INITIAL FIRE SAFETY INSPECTION REPORT

GENESIS FASHIONS LTD. (Extension - 2)

RSC ID: 26201

Date: 21 April, 2025

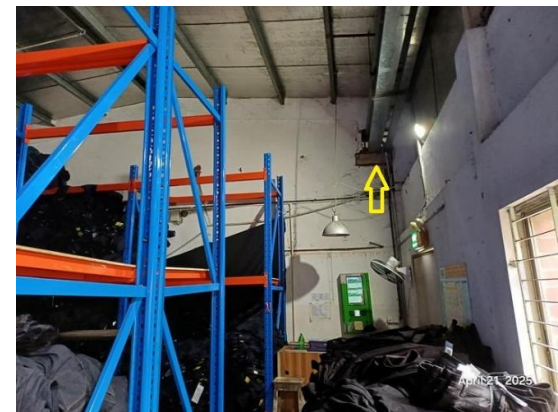
SI No.	Category	Findings	Required Action	Remediation Time Frame
F1	Fire Rated Construction	The required fire separation distance for Building-01: Whisker Shed does not comply with the requirements of BNBC 2006.	The exterior walls shall have a fire resistance and opening protection as specified in BNBC 2006, Part 3 Section 2.4.1.3. & Tables 3.2.2	Within 6 Months

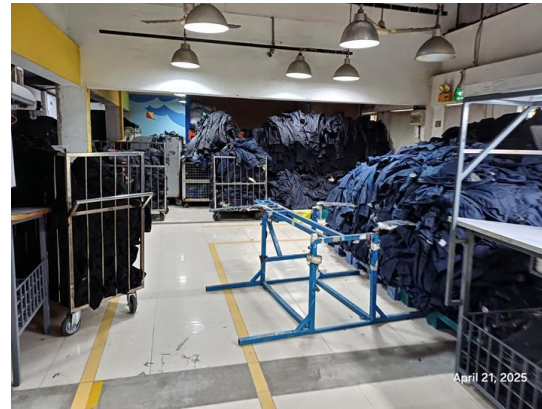
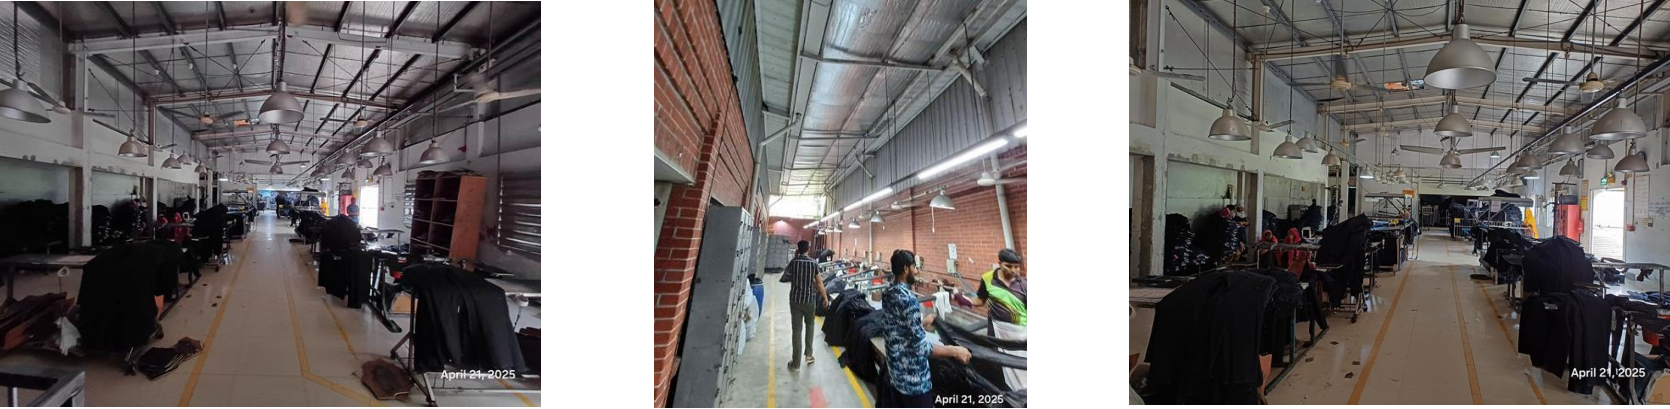
SI No.	Category	Findings	Required Action	Remediation Time Frame
F3	Fire Rated Construction	<p>Areas used for in-process storage of combustible materials are open to the surrounding occupancy.</p> <p>Location: Ground floor of Whisker Shed</p>	<p>Provide defined storage areas and limit the storage arrangement as follows:</p> <p>Maximum height of 2.45 m and maximum area of 23 m² and is separated by a minimum 3.0 m (10ft) from other storage areas and they do not exceed 10 percent of the building area of the story in which they occur.</p> <p>or,</p> <p>If sprinkler protected, Maximum height 12 ft (3.66 m) and maximum area of 1000 ft² (93 m²) and separated by a at least 25 ft (7.62 m) and does not constitute more than 10 percent of the building area or 4000 ft² (372 m²) of the sprinklered area, whichever is greater.</p> <p>or,</p> <p>Enclose the storage area from the surrounding occupancy with a minimum 1 hour construction.</p>	Within 3 Months

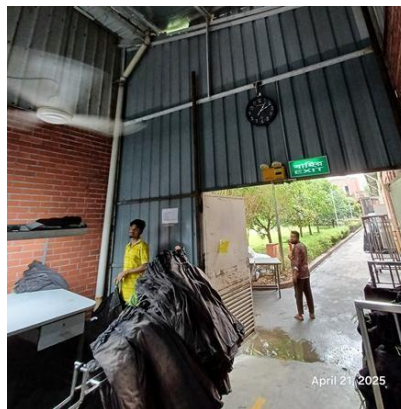
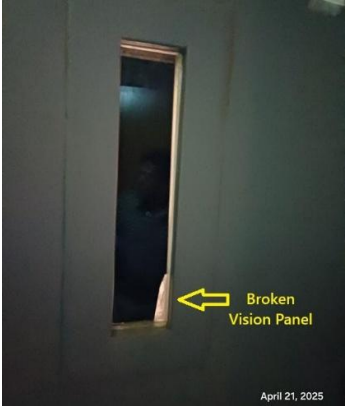
SI No.	Category	Findings	Required Action	Remediation Time Frame
F11	Means of Egress	<p>Building does not have occupant load signs at required locations on all floors.</p> <p>Location: All Exits in Whisker Shed</p>	<p>Post the occupant load for every assembly and production floor in a facility in a conspicuous space near the main exit or exit access doorway for the space in accordance with RSC Technical Guidelines (Standard)¹ V1.0 Section 6.4.4 .</p>	<p>Within 1 Month</p>

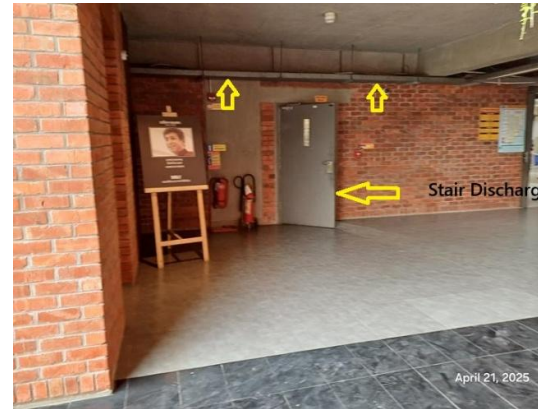
SI No.	Category	Findings	Required Action	Remediation Time Frame
F13	Means of Egress	<p>Unsealed penetrations and openings are located in exit stair enclosures. Electrical cable/ BBT raceway passing through the exit enclosure.</p> <p>Location(s): south-east stair-1 on ground and 2nd floor of Annex Building</p>	<p>No other penetration into and through the exit enclosure except for fire alarm equipment electrical raceway, required exit doors, sprinkler piping, standpipes, and electrical conduit serving the exit enclosure is permitted in accordance with section 6.14.4 of RSC Technical Guidelines (Standard)¹ V1.0. So, relocate the electrical wires/raceways to somewhere else avoiding the exit enclosure, and seal the created unprotected openings with a minimum of 1.5 hours listed/certified fire-rated materials. Installation shall be as per manufacturer published installation guideline and the certification authority guideline to ensure the fire-rating. Or seal the penetration by 2-hr masonry construction.</p>	Within 3 Months

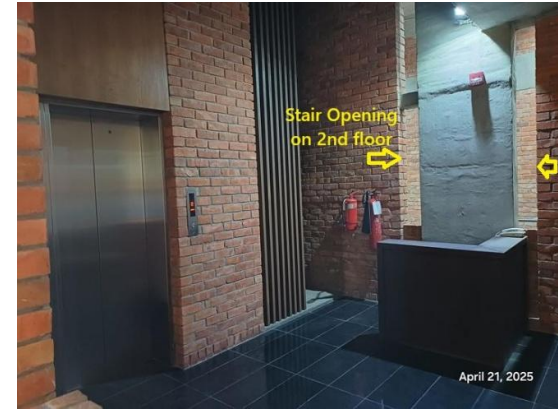
SI No.	Category	Findings	Required Action	Remediation Time Frame
F15	Fire Rated Construction	<p>Elevator/ Lift shafts open directly into the exit enclosure on 2nd floor and protected discharge on ground floor, which doesn't comply with RSC Technical Guidelines (Standard) , section 6.14.3.</p> <p>Location: Lift Shaft near Stair-1 in Annex Building</p>	<p>Provide a minimum 2-hr fire rated elevator shaft to separate it from stair enclosure. No discharge is accepted through elevator shaft. Seal all openings to maintain fire separations.</p>	<p>Within 3 Months</p>

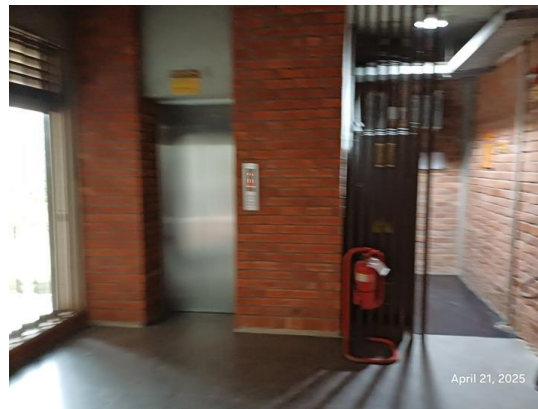
SI No.	Category	Findings	Required Action	Remediation Time Frame
F16	Fire Rated Construction	<p>Elevator shafts open directly into the production or office floor without proper fire separation due to unprotected opening.</p> <p>Location: Production area on all floors of Annex Building</p>	<p>Elevator shaft shall be separated from production area by 2 hours fire rated construction. 2-hr fire barriers shall be protected with minimum 1.5-hr fire protective opening assemblies.</p>	<p>Within 3 Months</p>

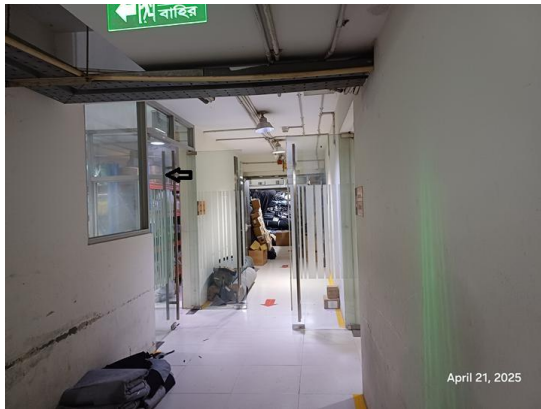
SI No.	Category	Findings	Required Action	Remediation Time Frame
F18	Fire Rated Construction	<p>Rooms used for storage of combustible materials are not separated from the surrounding occupancy.</p> <p>Location: Store on 1st floor adjacent to production and sub-chemical store adjacent to printing section on ground floor of Annex Building.</p>	<p>Rooms used for storage of combustible materials shall be separated from the surrounding occupancy with a minimum 1 hour construction in accordance with section 3.4.2.1.5 of RSC Technical Guideline (Standard).</p>	Within 3 Months

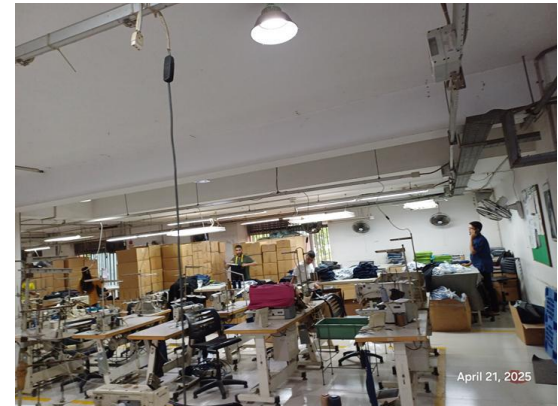
SI No.	Category	Findings	Required Action	Remediation Time Frame
F19	Fire Rated Construction	<p>Areas used for in-process storage of combustible materials are open to the surrounding occupancy.</p> <p>Location: On 1st floor of Annex building</p>	<p>Provide defined storage areas and limit the storage arrangement as follows: Maximum height of 2.45 m and maximum area of 23 m² and is separated by a minimum 3.0 m (10ft) from other storage areas and they do not exceed 10 percent of the building area of the story in which they occur.</p> <p>or,</p> <p>If sprinkler protected, Maximum height 12 ft (3.66 m) and maximum area of 1000 ft² (93 m²) and separated by a at least 25 ft (7.62 m) and does not constitute more than 10 percent of the building area or 4000 ft² (372 m²) of the sprinklered area, whichever is greater.</p> <p>or,</p> <p>Enclose the storage area from the surrounding occupancy with a minimum 1 hour construction.</p>	Within 3 Months

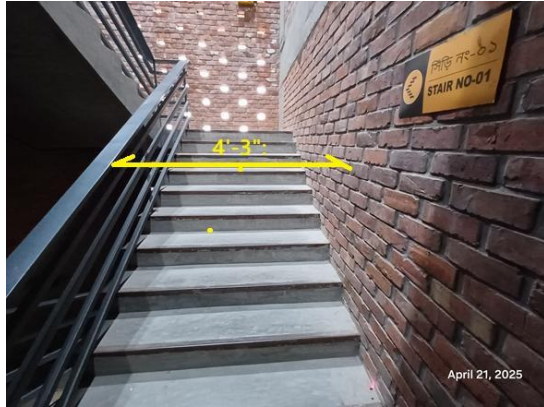
SI No.	Category	Findings	Required Action	Remediation Time Frame
F22	Means of Egress	<p>Each of the Stair clear width is found less than 60 in.</p> <p>Location: South-East Stair-1 and North-West Stair-2 in Annex Building</p>	<p>Stairs shall have a minimum clear width of 60 in. for all industrial occupancies as per RSC Technical Guideline (Standard) section of 6.5.6</p>	<p>Within 3 Months</p>

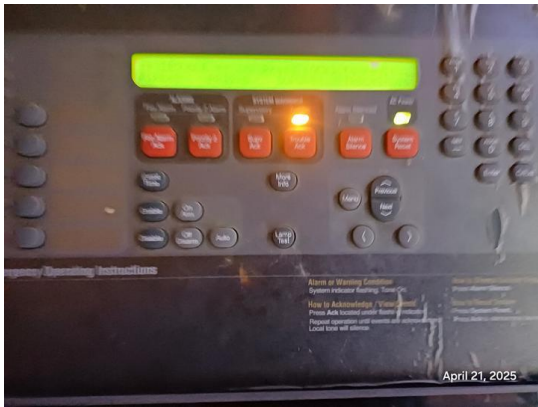
SI No.	Category	Findings	Required Action	Remediation Time Frame
F24	Fire Alarm & Detection System (FADS)	<p>The factory has installed a fire alarm and detection system that requires a detailed review to confirm compliance with NFPA 72 and RSC Technical Guidelines (Standard).</p> <p>Location: Annex Building</p> <p>Note- FACP is located at common area on ground floor of Annex Building. FACP serves 3 Storied Annex building, Single Storied Store Building-02 and 3 storied child care, medical and dining building.</p>	<p>Submit the fire alarm and detection system design to RSC for review.</p> <p>Once the design is reviewed, install and modify the fire detection and alarm system throughout the building in accordance with review comment, RSC Technical Guidelines (Standard) and NFPA 72.</p> <p>After installation/modification the owner shall conduct internal testing and commissioning and then contact the RSC for witness of final acceptance testing.</p>	<p>Design within 2 month and modification/ installation with 4 months</p>

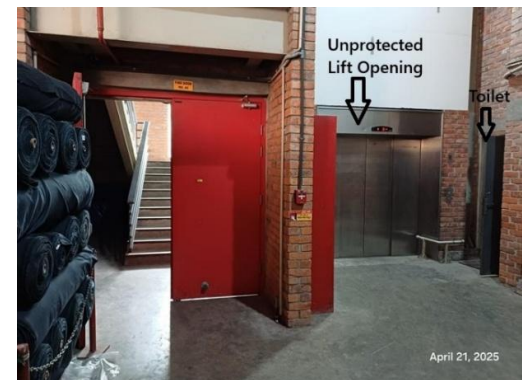
SI No.	Category	Findings	Required Action	Remediation Time Frame
F-37	Means of Egress	<p>Exit stair-1 (South-East) terminates the occupants inside the building which does not comply with section 6.17 of RSC Technical Guidelines (Standard)¹ V1.0.</p> <p>Location: South-West Exit Stair-1 Discharge on ground floor of Store Building-01.</p> <p>Non-compliance reason: On ground floor, Unsealed openings are found (i) From Storage area; (ii) From Lift Shaft and Toilet zones. Loading Unloading area on ground floor.</p>	<p>Exits shall discharge directly to the exterior of the building unless meeting the requirements of 6.17.2 or 6.17.3 as per RSC Technical Guidelines (Standard)¹ V1.0.</p>	<p>Within 3 Months</p>

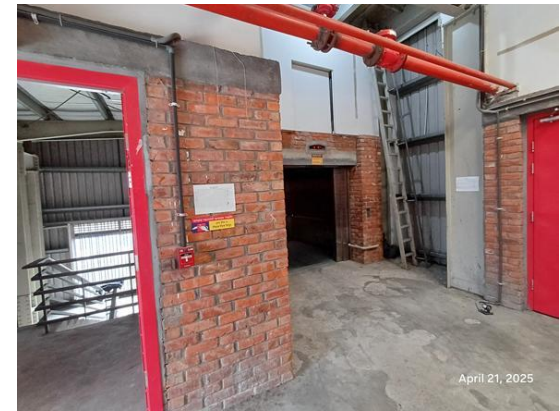
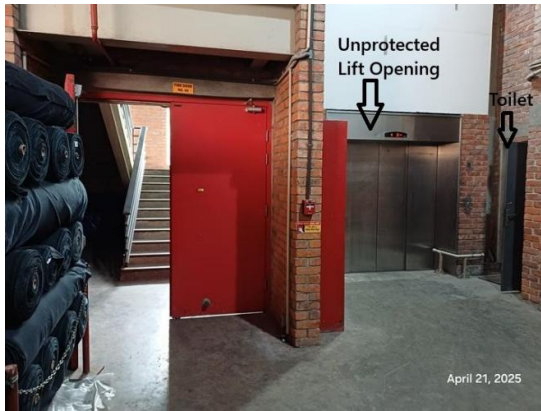
SI No.	Category	Findings	Required Action	Remediation Time Frame
F-38	Fire Rated Construction	<p>Elevator shafts open directly into the Store, production or office floor without proper fire separation due to unprotected opening.</p> <p>Location: Storage and production area on ground, 1st and 4th floor of Store Building-01</p>	<p>Elevator shaft shall be separated from production area by 2 hours fire rated construction. 2-hr fire barriers shall be protected with minimum 1.5-hr fire protective opening assemblies.</p>	<p>Within 3 Months</p>

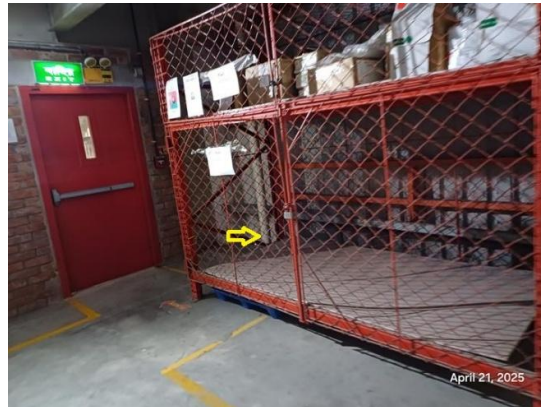
SI No.	Category	Findings	Required Action	Remediation Time Frame
F-39	Fire Rated Construction	<p>Penetrations through floor/ceiling assemblies are found unsealed due to plumbing PVC Pipes.</p> <p>Location: All Floor of Store Building</p>	<p>Seal all penetrations and openings in floor/ceiling assemblies by a listed through-penetration fire stop system tested in accordance with ASTM E814 or approved alternative standard to maintain minimum 2-hr. fire resistance rating. Installation shall be as per manufacturer published installation guideline and the certification authority guideline to ensure the fire-rating in accordance with section 4.7 of RSC Technical Guideline (Standard)</p> <p>Or,</p> <p>Provide a minimum 2-hr fire rated shaft to separate the penetration from each floor if required.</p>	Within 3 Months

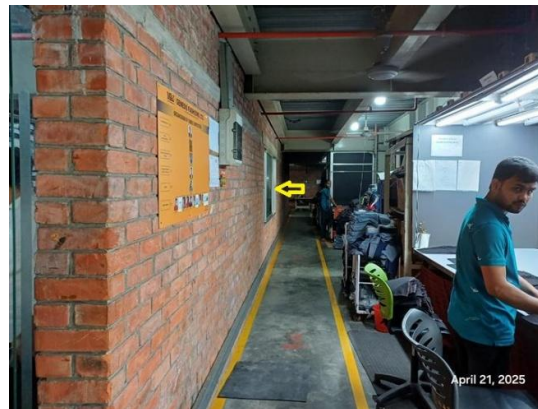
SI No.	Category	Findings	Required Action	Remediation Time Frame
F-40	Fire Rated Construction	<p>Rooms used for storage of combustible materials are not separated from the surrounding occupancy.</p> <p>Location: Store on 1st & 3rd floor adjacent to inspection & office area respectively in Store Building-01.</p>	<p>Rooms used for storage of combustible materials shall be separated from the surrounding occupancy with a minimum 1 hour construction in accordance with section 3.4.2.1.5 of RSC Technical Guideline (Standard).</p>	Within 3 Months

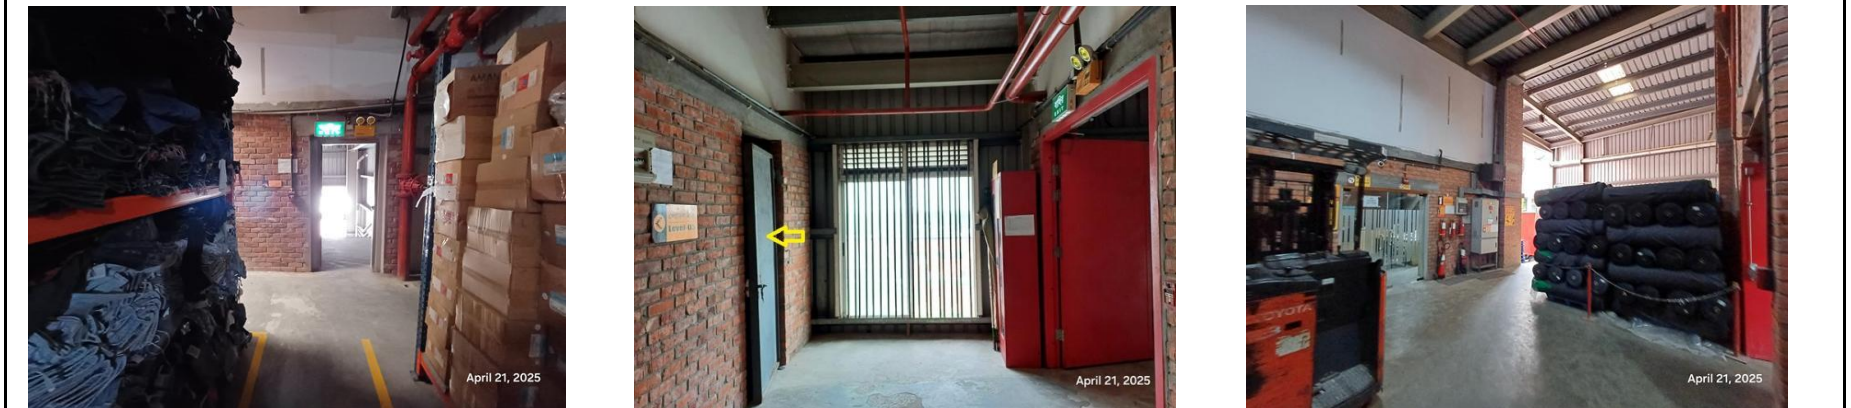
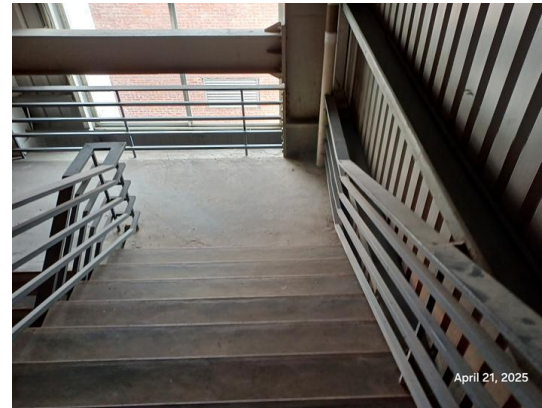
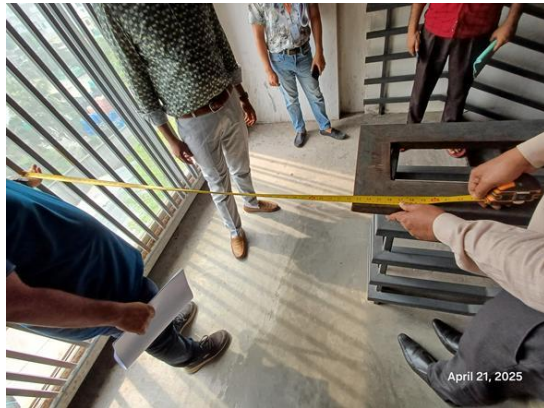
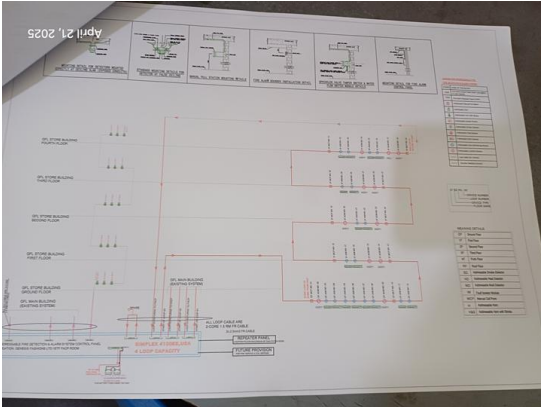
SI No.	Category	Findings	Required Action	Remediation Time Frame
F-41	Means of Egress	Storage areas discharges directly into the south-east exit stair-2 enclosure in all floors and into the south-west stair-1 enclosure on ground and 4th floor.	<p>Openings from exit enclosure to Storage areas/ basements/ transformer rooms/ generator rooms/ boiler rooms and similar normally unoccupied spaces shall be provided with a vestibule with fire rated construction and openings in accordance with section 6.14.3 of RSC Technical Guidelines (Standard)¹ V1.0. Provide a min 1-hr fire rated door on the exit stair side and a 1.5 hr. fire rated door on the Store, generator, sub-station room side . Ensure that the fire rating of the vestibule construction matches that of the exit stair enclosure as per RSC Technical Guidelines (Standard)¹ V1.0. section 6.14.3. The minimum width for vestibules shall not be less than 1.1m and length 1.8m.</p> <p>Or, Provide Sprinkler System in accordance to NFPA-13.</p>	Within 3 Months

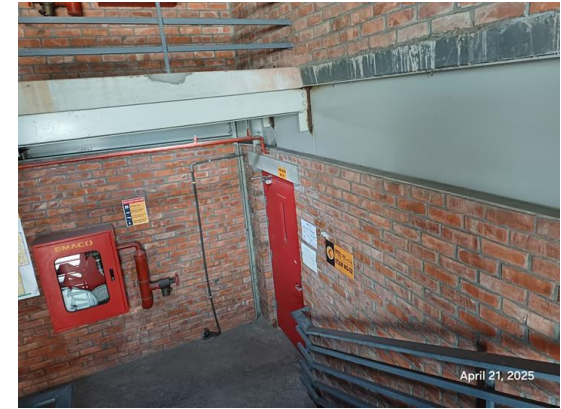
SI No.	Category	Findings	Required Action	Remediation Time Frame
F-48	Fire Suppression System (SUPS)	<p>The factory has installed a standpipe & Hose system that requires a detailed review to confirm compliance with NFPA 14,20, 24 and RSC Technical Guidelines (Standard).</p> <p>Location: 5 Storied Store Building-01</p>	<p>Submit the standpipe system drawing to RSC for review.</p> <p>Once reviewed, install or modify the standpipe system throughout the building in accordance with RSC Technical Guidelines (Standard)¹ V1.0. and NFPA 14, 20,22 and 24.</p> <p>After installation the owner shall contact the RSC for witness of conducting the final acceptance testing of the standpipe system.</p>	<p>Design within 2 month and modification/ installation with 4 months</p>

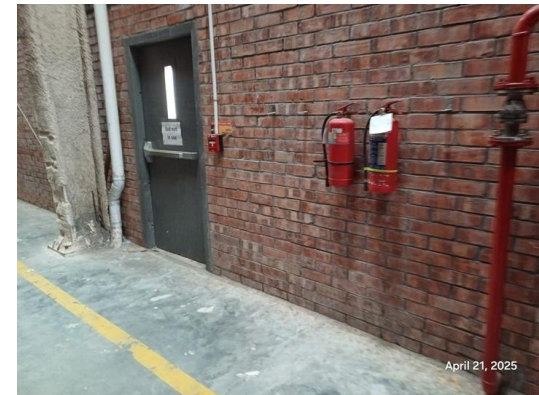
SI No.	Category	Findings	Required Action	Remediation Time Frame
F-61	Means of Egress (Exit Adequacy)	<p>A single means of exit has been provided on ground floor of store building-02. Another door is found which declared as not an exit.</p> <p>Location: Single Storied Store Building-02</p> <p>Occupant Load: 30 Travel distance: 70.0m</p>	<p>The number of means of egress from any floor, story or portion thereof shall not be less than 2 except where a single exit is permitted by RSC Technical Guideline (Standard), section 6.6.2.</p> <p>Provide additional exit and ensure that the exit doors or means of egress openings are located a distance apart as per RSC Technical Guideline (Standard) section of 6.6.6. Ensure that travel distance does not exceed 38.0m or for fully sprinklered building travel distance does not exceed 45.0m.</p>	Within 3 Months

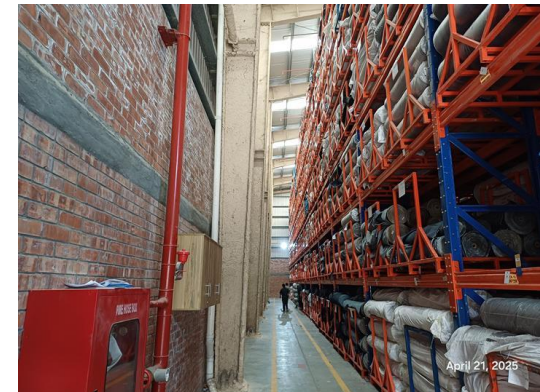
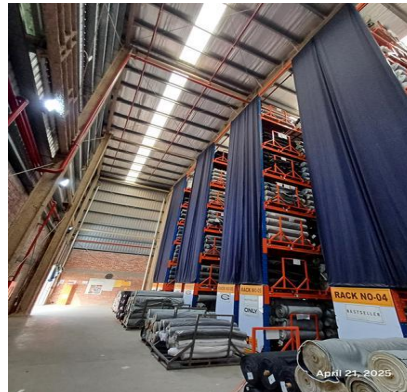
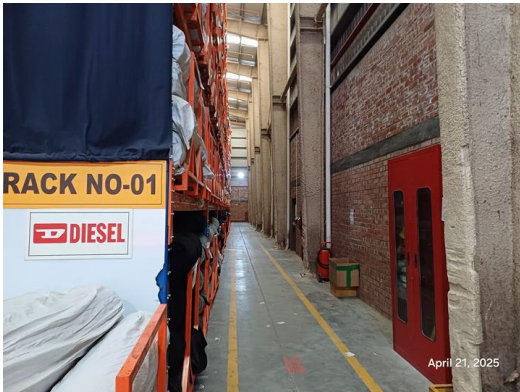
SI No.	Category	Findings	Required Action	Remediation Time Frame
F-64	Sprinkler system Design & Installation	<p>Sprinkler system is not mandatory for the building based on height and type of construction but the system installed for the building along with standpipe system in lieu of automatic detection system. Both the system requires detailed review to confirm compliance with NFPA 13, 14, 20, 22, 24 and RSC Technical Guidelines (Standard).</p> <p>Location: Single Storied Store Building-02</p>	<p>Submit the sprinkler system drawing to RSC for review. Once the design is reviewed, install and modify the sprinkler/standpipe system throughout the building in accordance with review comment, RSC Technical guideline (Standard) and NFPA 13,14,20,22 and 24. After installation the owner shall conduct internal testing and commissioning and then contact the RSC for witness of final acceptance testing.</p> <p>(Provide automatic sprinkler protection along with class-I standpipe system throughout the building in accordance with NFPA 13, 14, 20 and 22. Submit design to RSC for review prior installation.)</p>	Design within 2 month and modification/ installation with 4 months

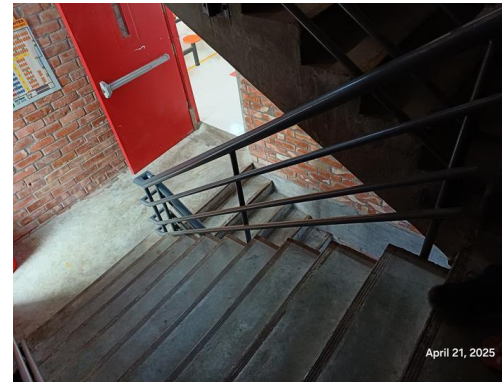
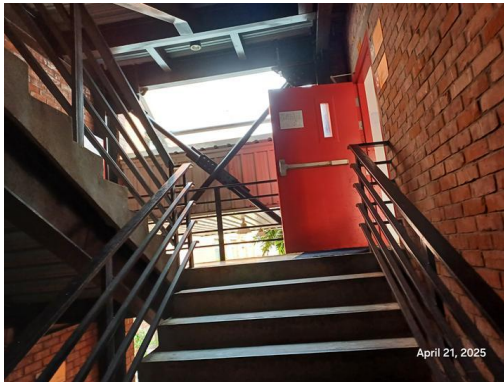
SI No.	Category	Findings	Required Action	Remediation Time Frame
F-75	Means of Egress (Exit stair openings)	<p>The exit stair enclosures are not separated from work areas and other spaces on each floor by fire-rated construction.</p> <p>Location: 3 Storied Daycare, Medical & Dining Building</p> <p>Non-compliance reason: (i) Proper certification is not available for fire rated doors</p>	<p>The exit stair enclosure shall be provided with a minimum 1-hr fire resistance rating for buildings with 3 or fewer stories. Provide 1-hr. fire rated door and seal all penetrations and openings by 1 hr. fire rated fire rated barrier construction for building with 3 or fewer stories in accordance with section 6.3.1.2 of RSC Technical Guidelines (Standard)¹ V1.0.</p> <p>Ensure that the fire doors are self-closing and positive latching and that they are provided with fire exit (panic) hardware where serving production floors. If fire doors are required to be held open for functional reasons, provide automatic closing devices tied to the fire alarm system.</p> <p>Keep proper datasheet & certifications for installed fire doors & accessories on-site for verification. The clearance under the bottom of a door shall be a maximum of 3/4 in. (19 mm).</p>	Within 3 Months
